Proposed Residential Redevelopment	■
Broom Road, Teddington TW11 9BE	■
Teddington Riverside	■
Environmental Statement – Addendum	■

- 1.1.1 This document is produced as an Addendum to the Environmental Statement submitted to the Council in March 2014. It arises from the Councils consideration of the planning application and the submitted Environmental Statement and consultation responses received. This has resulted in the Council originally issuing a letter dated 30th May seeking an Addendum under Regulation 22 of the Town and Country Planning (Environmental Assessment) (England and Wales) Regulations 2011.

Figure A9.8.2: Flue Location

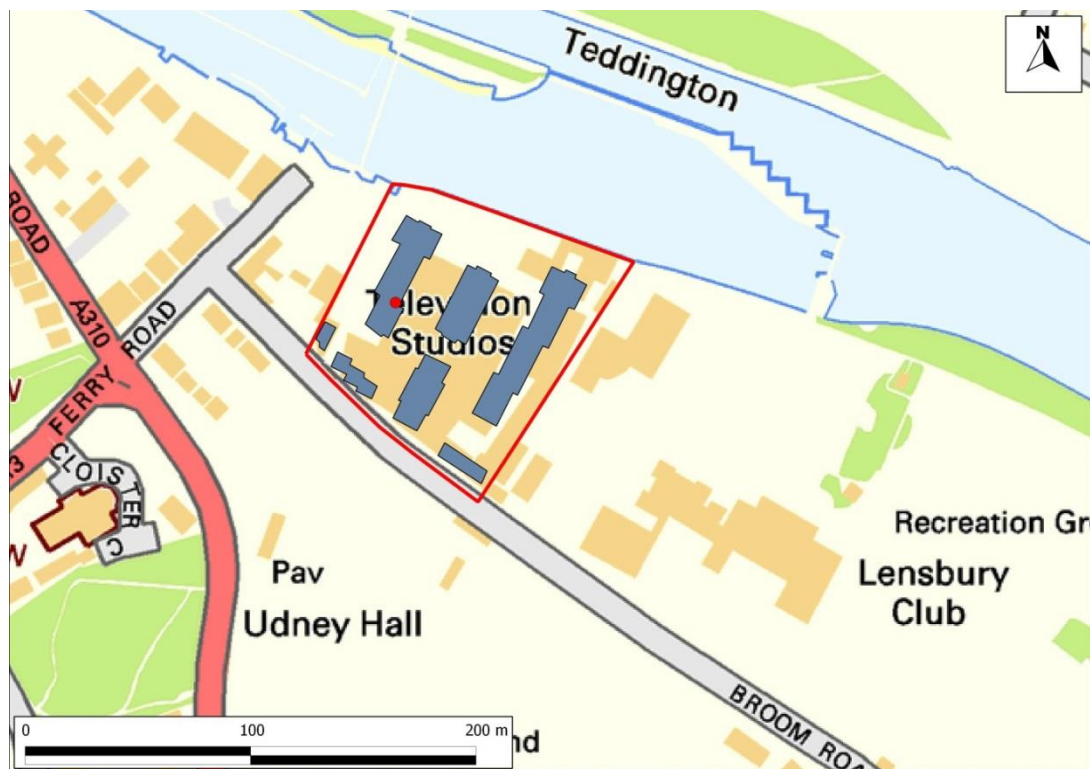
7.1.11 The model input parameters have been provided by Cundall. The building dimensions and flue location have been obtained from drawings provided by TP Bennett. The location of the flue is shown in **Figure A9.8.2**. The flue has been modelled at a height of 17.5 m (2 m above the roof level of Block A).
